UNITED STATES OF AMERICA  
BEFORE THE  
FEDERAL ENERGY REGULATORY COMMISSION

In the Matter of	)	October 17, 2005
	)	
State of California	)	
Department of Water Resources	)	Project No. 2100-52
	)	
For a New Major License	)	
Oroville Division, State Water Facilities	)	
“Oroville Facilities”	)

**MOTION TO INTERVENE  
OF  
FRIENDS OF THE RIVER  
SIERRA CLUB  
SOUTH YUBA RIVER CITIZENS LEAGUE**

Figure 3 Sectional view looking upstream at main spillway with a small portion of the overpour spillway to the left. ACE Reservoir Regulation Manual, 1970

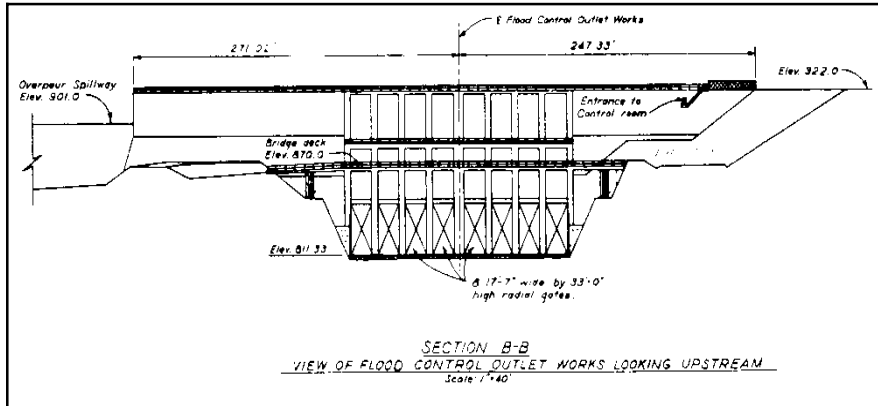
Oroville Dam includes two spillway facilities, the main spillway (controlled by gates) and an ungated “overpour” spillway, consisting of a 1,730 ft

long spillway lip (ogee crest) at elevation 901 feet, with no spillway below. Maximum surcharge operations envision 16 feet of water depth over the ungated spillway, plus additional freeboard space.<sup>3</sup>

Figure 4 Civil Works Projects Maps, ACE, Sacramento District, 1978

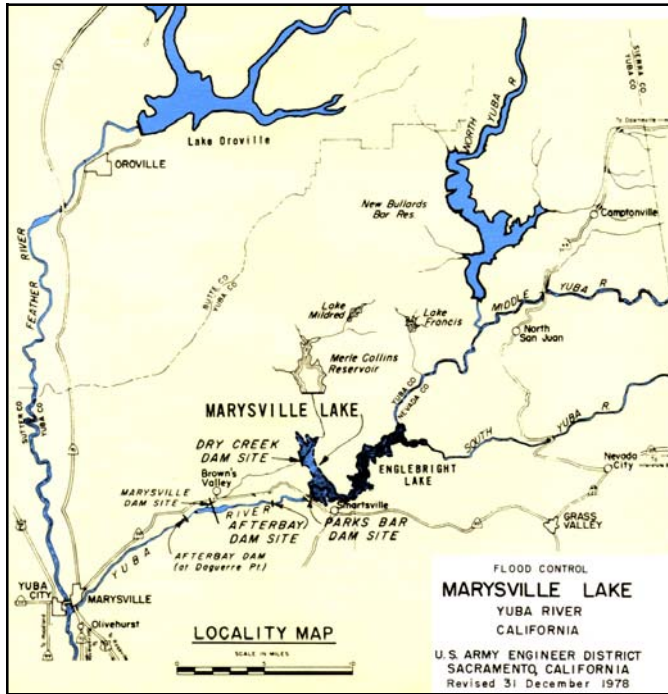
When the Orville Facilities were licensed and when the ACE Oroville Dam Reservoir Regulation Manual was promulgated, Marysville Dam (federally authorized in 1966)<sup>6</sup> was expected to be constructed and operational in the near future. Marysville Dam, located on the Yuba River system, was envisioned to be capable of regulating peak flows (resulting from inflows smaller than the standard project flood) entering the

Feather River from the Yuba River to 120,000 cfs.

**Figure 8. Lookdown View.** Main spillway gate above (with spillway extending to the right downslope). Ungated spillway below without any downslope spillway. See spillway sections used in figures 6 & 7. ACE, 1970

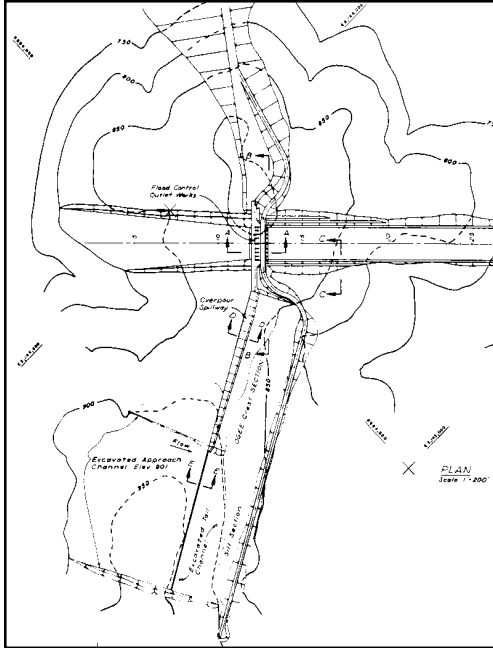
As noted earlier, the Commission has ample reasons to require spillway designs that limit damages associated with less frequent but still reasonably foreseeable releases—not just out of engineering preference associated with the Commission’s dam-safety program but to ensure that dam operators do not undertake actions to avoid use of auxiliary spillways when regulations and conditions call for their use. As noted earlier, operational experience and official reports on Oroville Dam’s flood operation capabilities appears to confirm the wisdom of the Commission’s

*Engineering Guidelines* on this subject. And for the licensee, the prospect of using (or avoiding the use) of an unarmored ungated spillway should not be just statistical abstraction: only eight years ago it believed that major ESRD releases were but hours away—and the licensee made over a day of releases from the main spillway in excess of the design release, avoiding combined-spillway releases, but experiencing major levee breaks downstream.
